LPP 1.6 Car Parking and Access Review  
Deputation to OMC 20 May 2025  
Dayle Kenny

**In the interest of Community Safety**

### Convex Mirrors

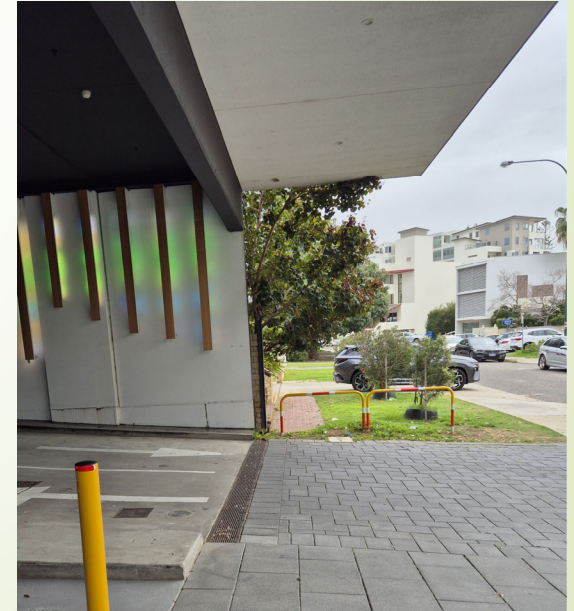
- Not maintained
- Poorly positioned
